BELFORD AVENUE OVER HAPPY CANYON CREEK  
72'30"00" SKEW (TO LAYOUT LINE)  
74'-0" ROADWAY WIDTH, EDGE OF SIDEWALK  
TO EDGE OF SIDEWALK (ULTIMATE)  
8'-6" SIDEWALKS

Print Date: 11/18/2016 8:09:49 AM	Sheet Revisions				As Constructed	BELFORD-HAPPY CANYON CREEK BRIDGE		Project No./Code
File Name: B115360-01INF01.dwg	Date	Comments	Initials		No Revisions:	GENERAL INFORMATION		
Horizontal Scale: VARIES Vertical Scale:				Revised:	Designer: J. LYNCH	Structure Numbers		
				Void:	Detailer: C. MIYAMOTO			
6300 South Syracuse Way, Suite 600 Centennial, CO 80111 tel 303.721.1440 fax 303.721.0832					Subset: BRIDGE	Sheets: B1 of 32		Sheet Number 11

**BELFORD-HAPPY CANYON CREEK BRIDGE**  
**SUMMARY OF QUANTITIES**

**TYPICAL SECTION**

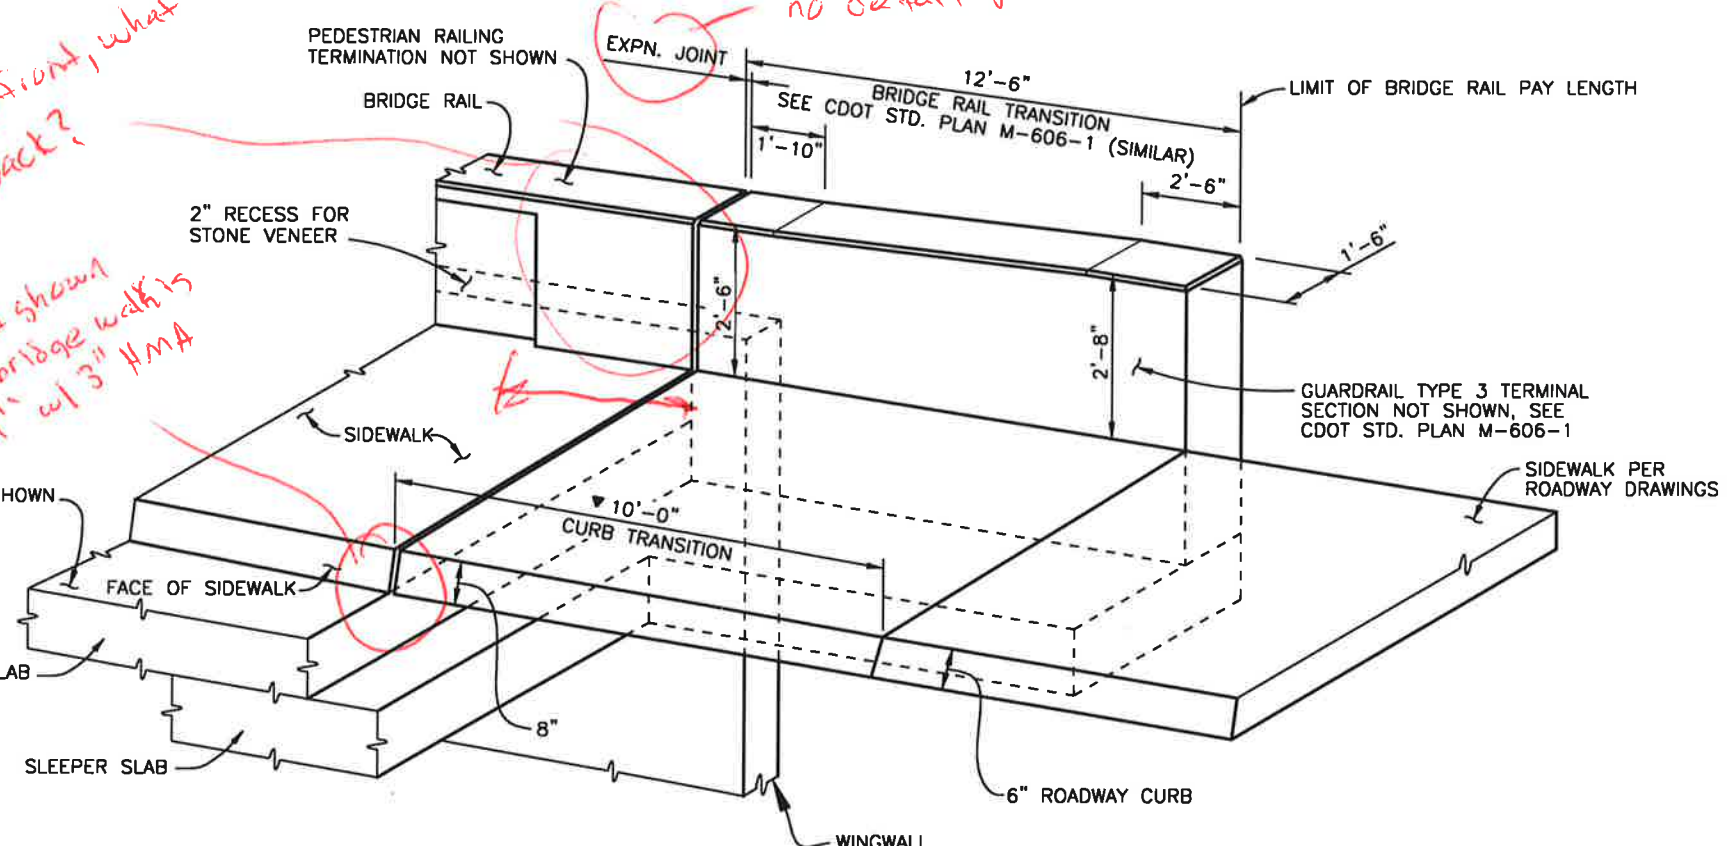
*no detail provided*

*show front, what dot back?*  
*this isn't shown correctly. bridge walk is 11' w/ 3" HMA*

*confusing to detail it this way why not just make it all Bridge Rail Special sheets 1 & 2?*

**LUMINAIRE DETAIL**

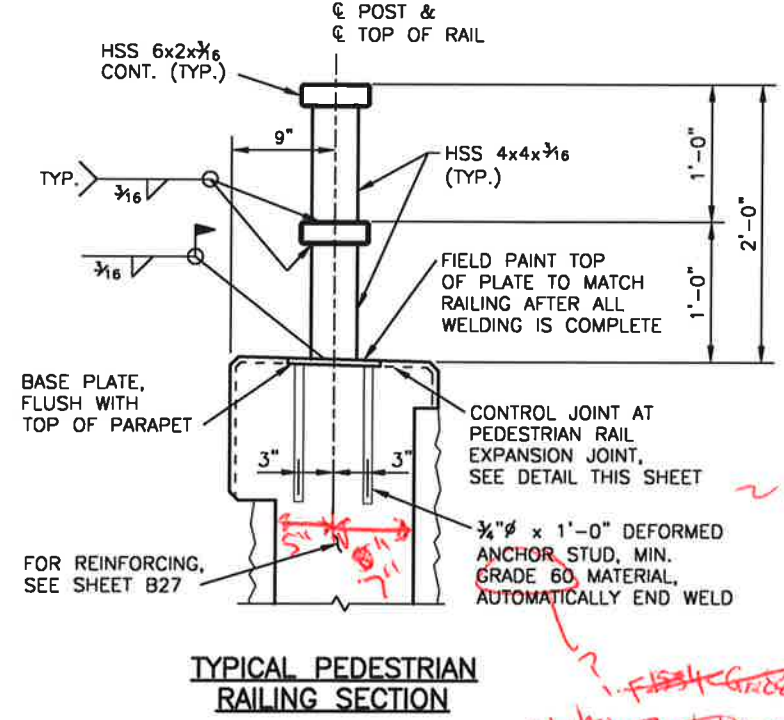
*how paying*

*2 section is flipped should be locking up instead unless shown otherwise*
